PROPOSED CHANGE ORDER

PROJECT: Montgomery High School

PCO #: 25

DESCRIPTION OF THE PROPOSED CHANGE: Added Landscaping Project

C-002

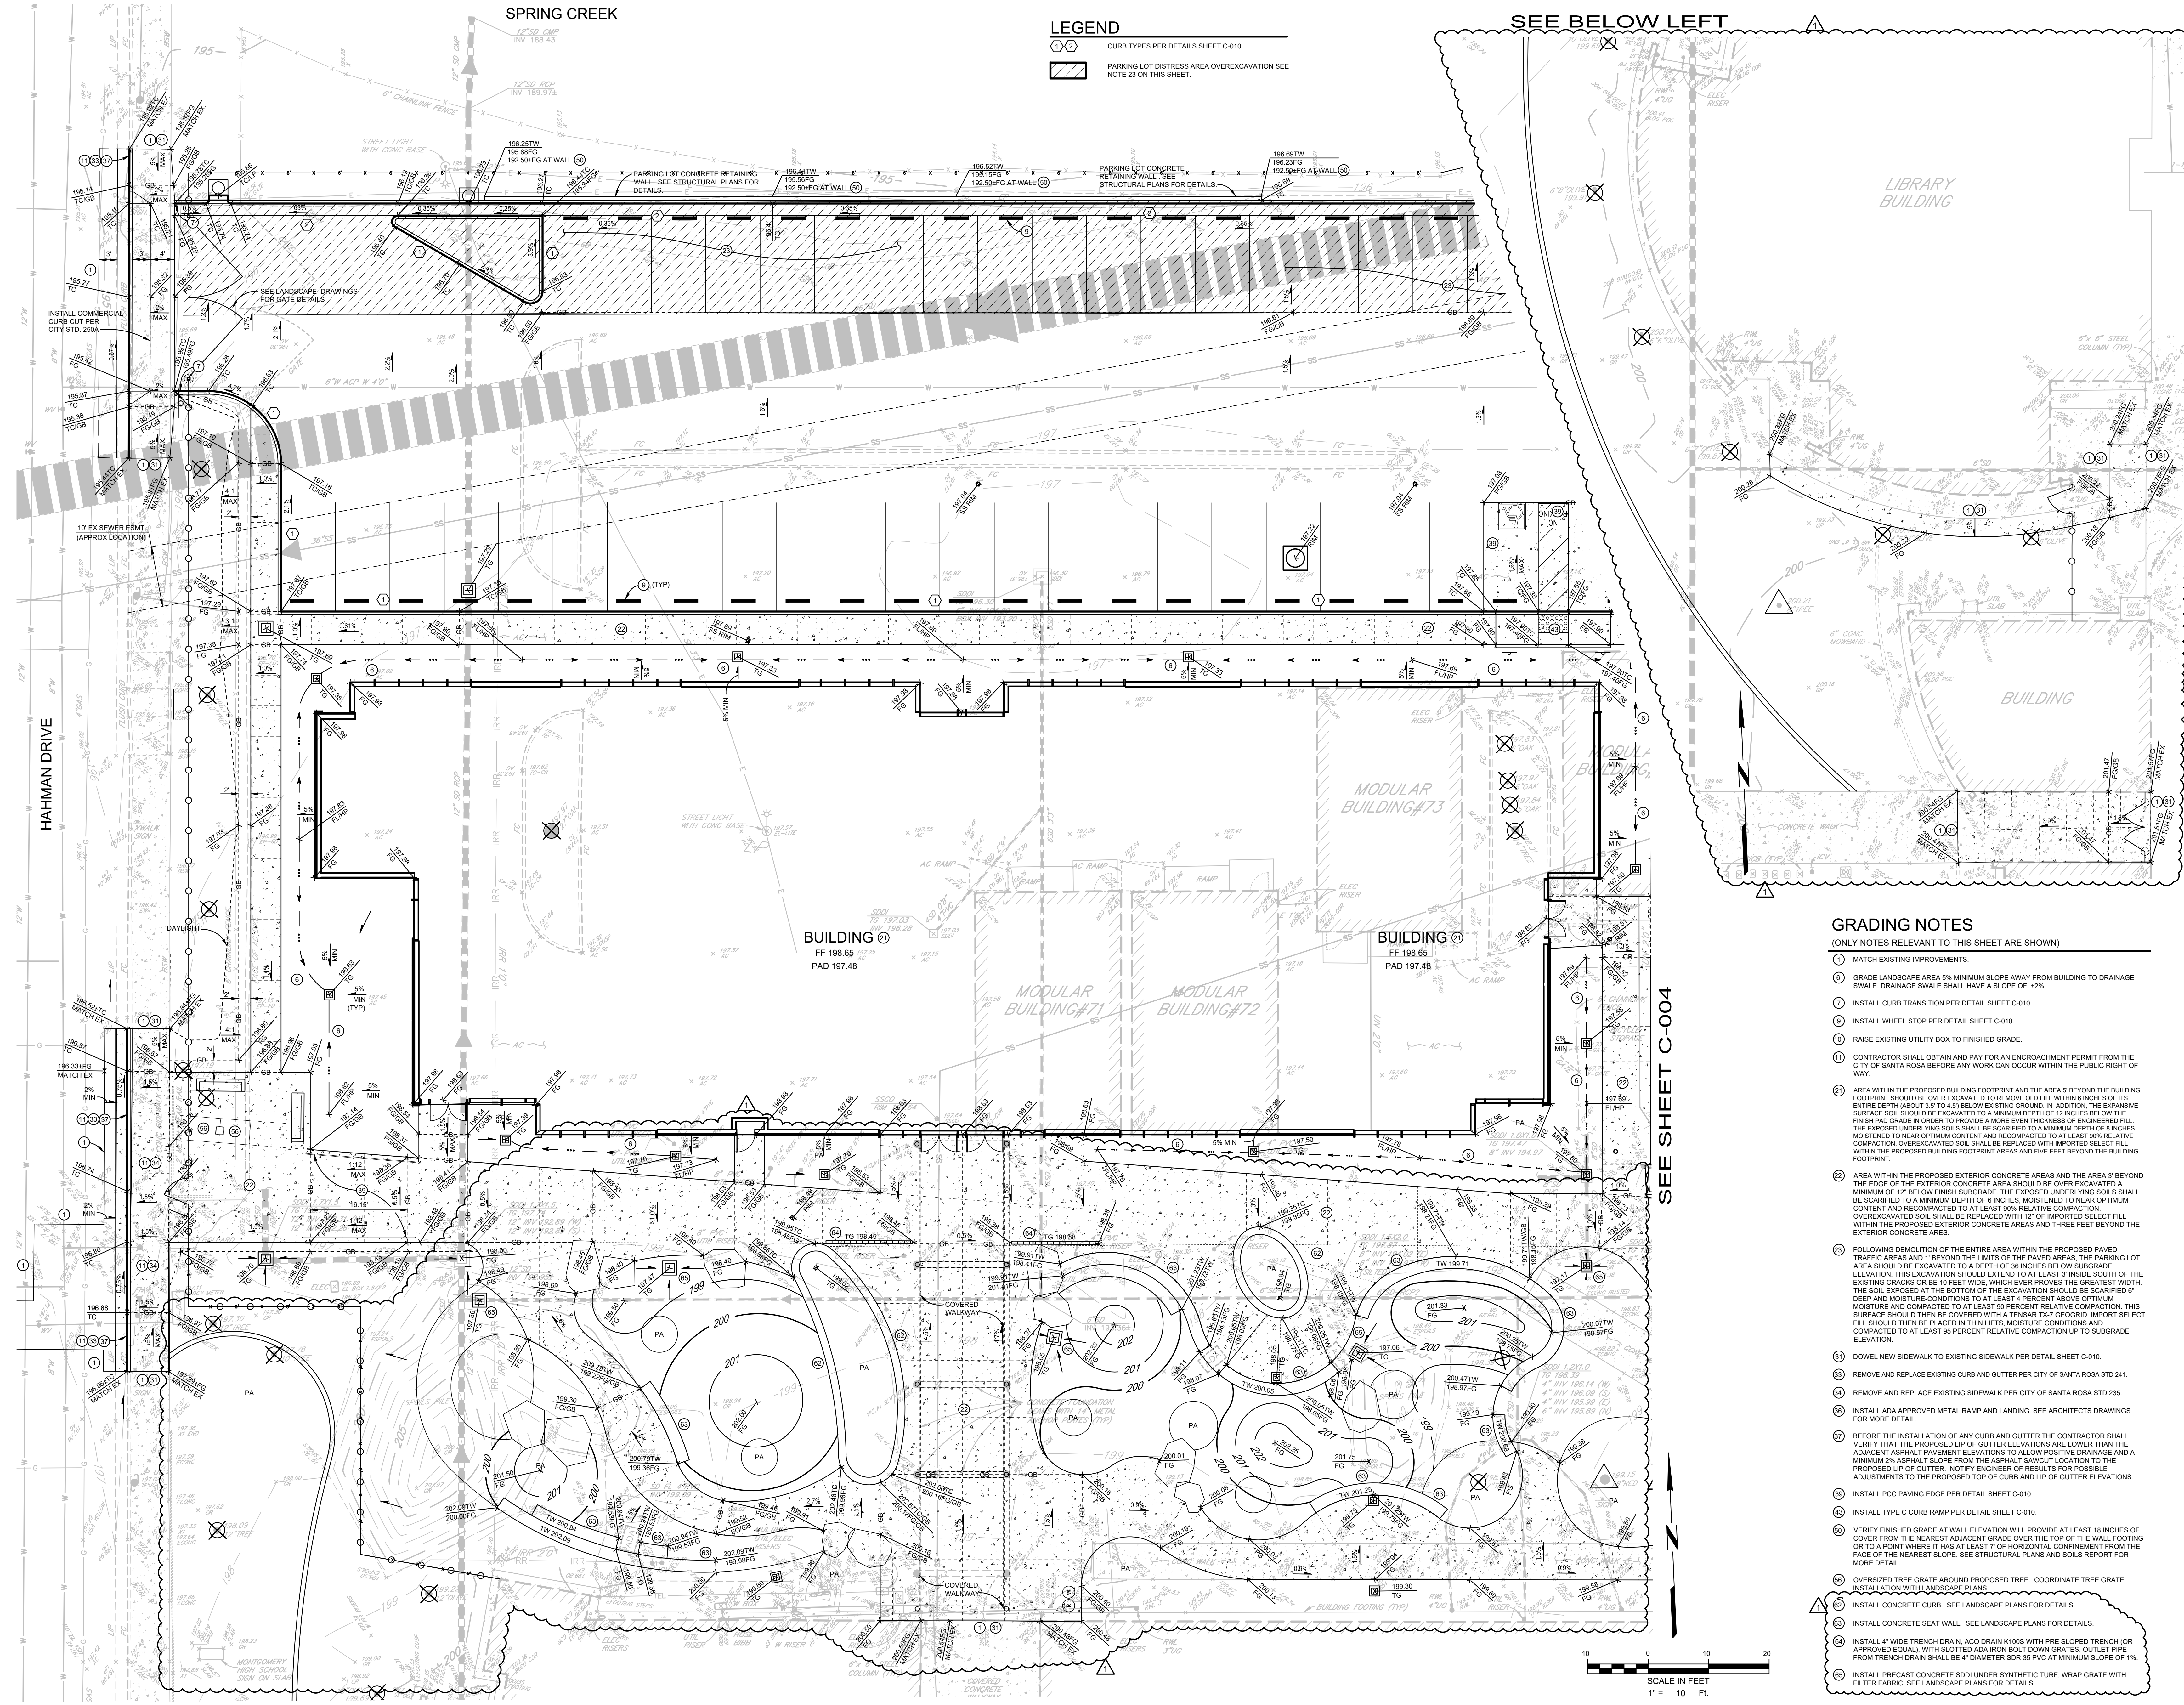
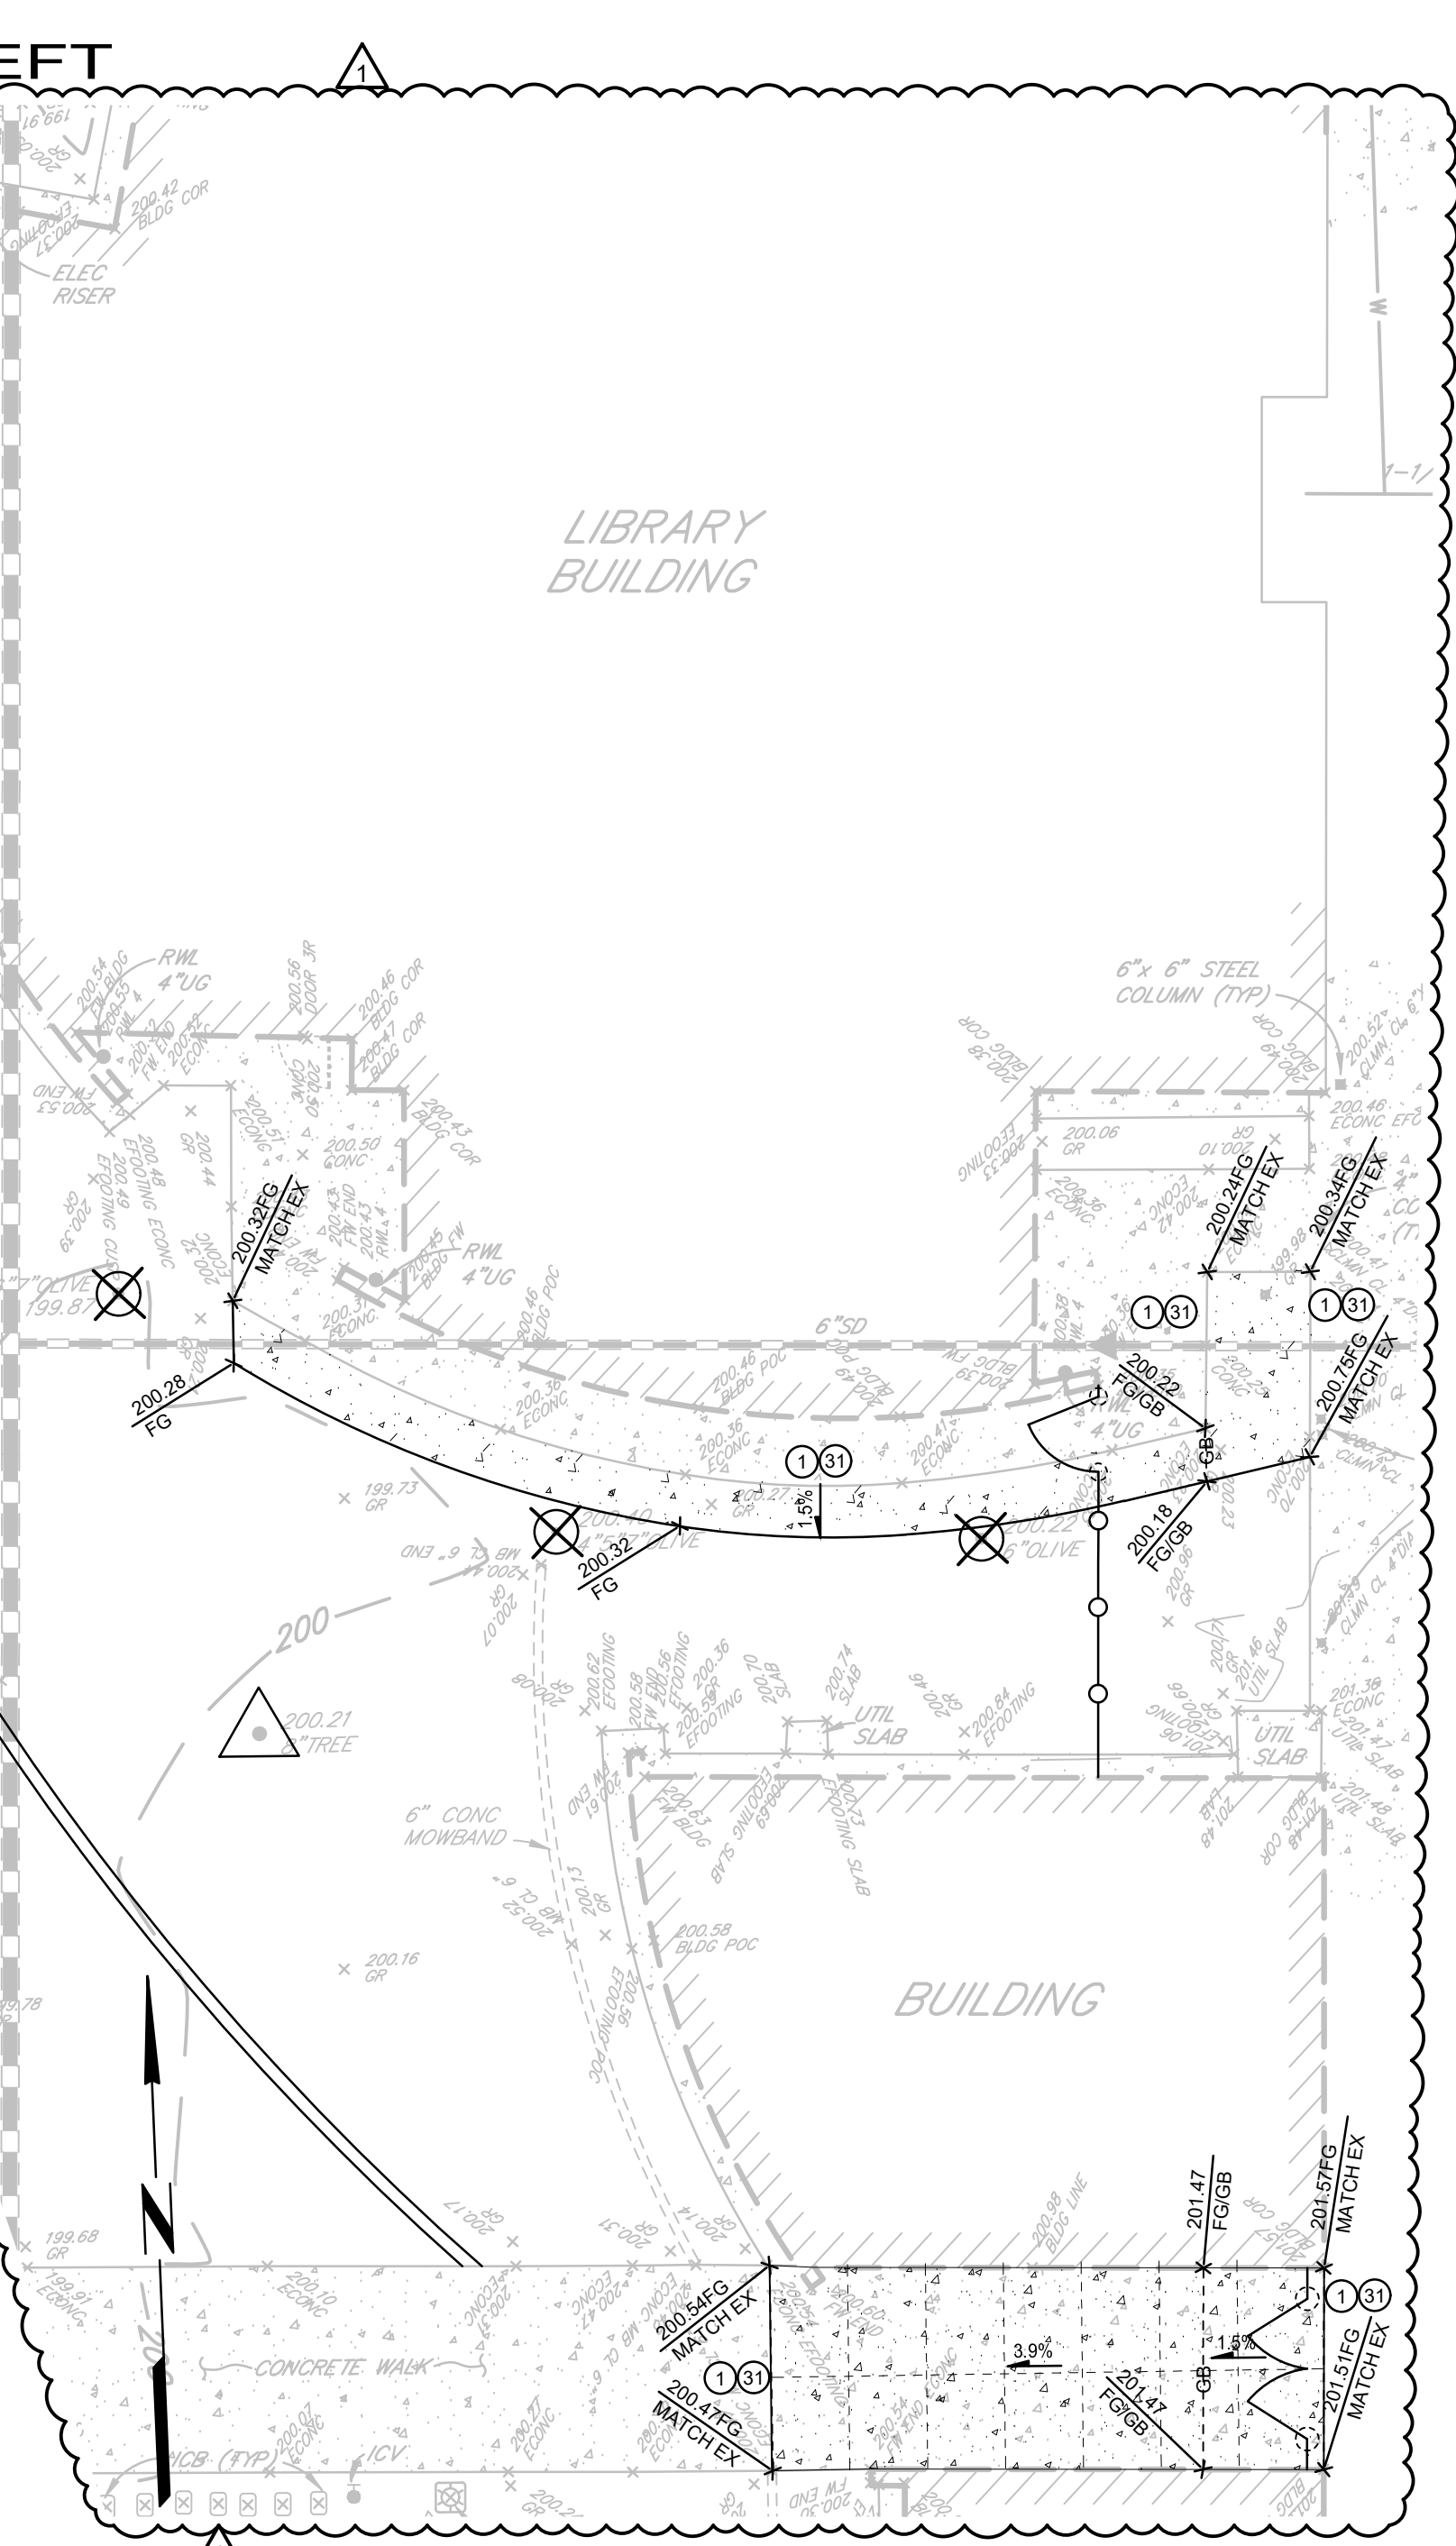
C-002	Update for removal of portable classrooms and associated paving and utilities
C-003	Add grading information for area south of new classroom building
C-004	Add grading information for area south of new classroom
C-005	Update utility information for area south of new classroom
C-006	Update utility information for area south of new classroom
C-007	Revise paving plan for new hardscape areas south of new classroom
C-008	Update layout for areas south of new classroom building
C-009	Add erosion control measures for new developed areas

L-104

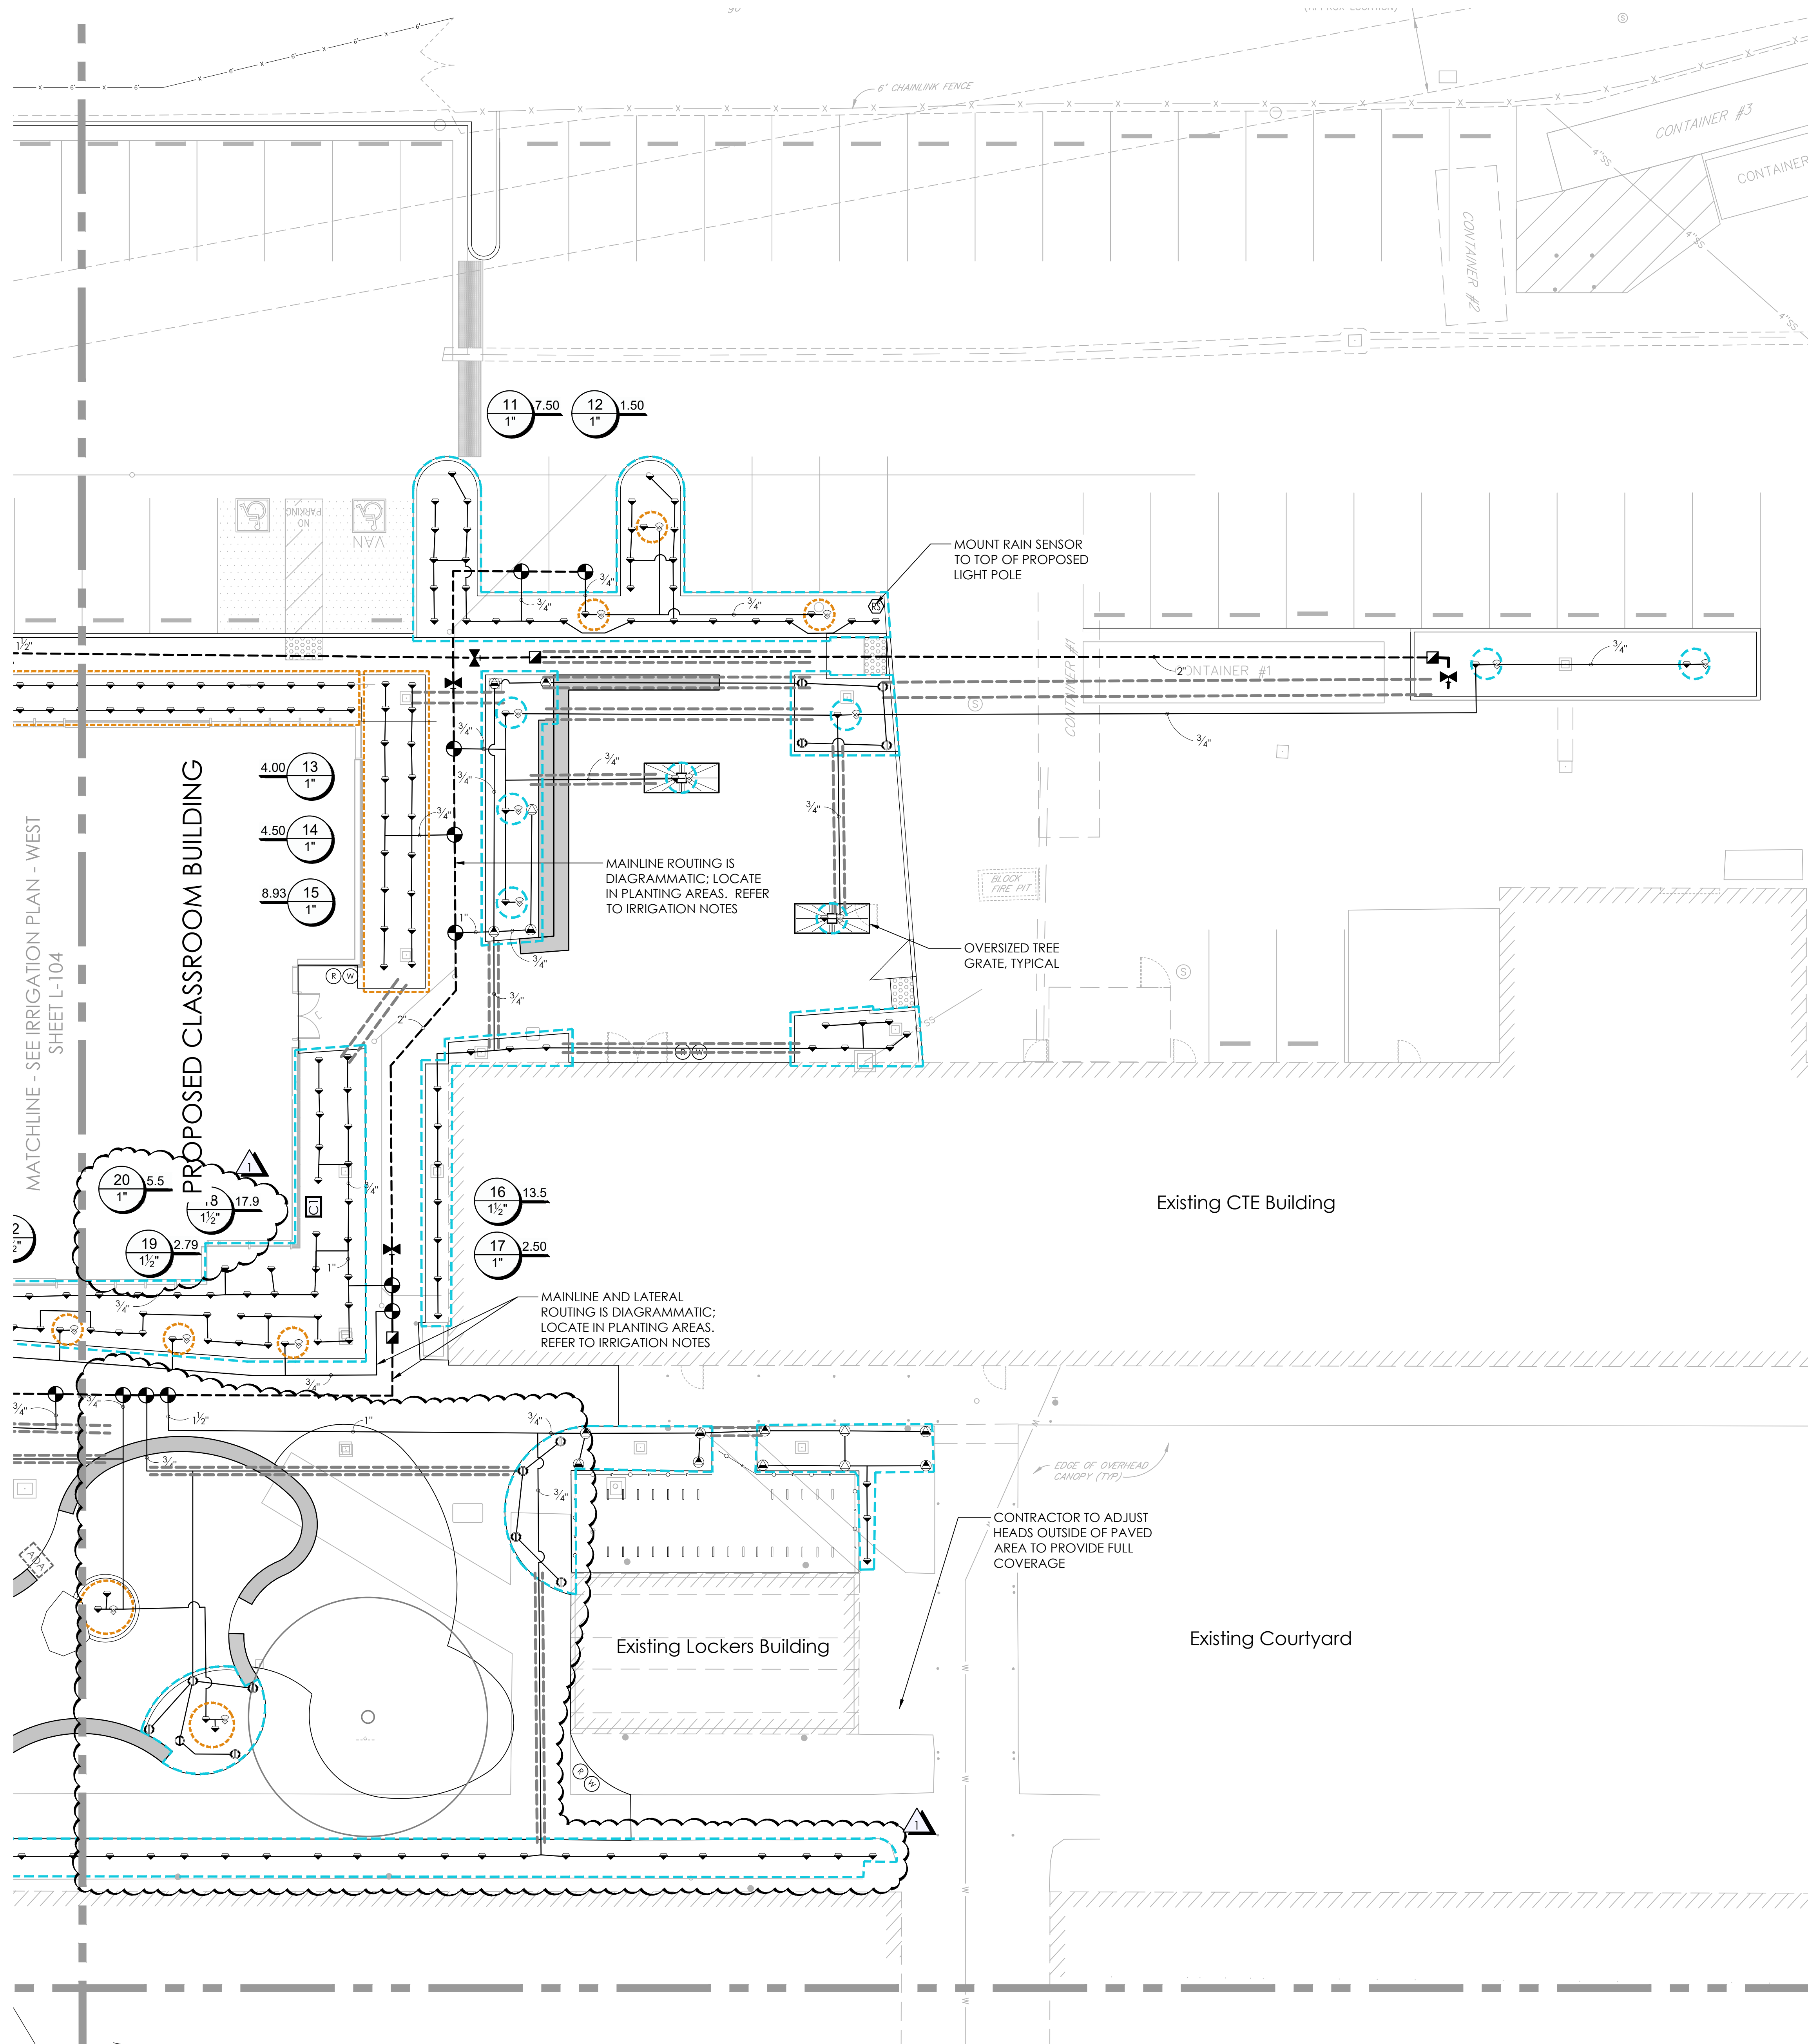
L-101	Added landscape design south of new classroom building
L-102	Added landscape design south of new classroom building
L-103A	Added new sheet to paving and gates added south of existing library building
L-104	Updated irrigation plan for newly developed area south of new classroom building
L-105	Updated irrigation plan for newly developed area south of new classroom building
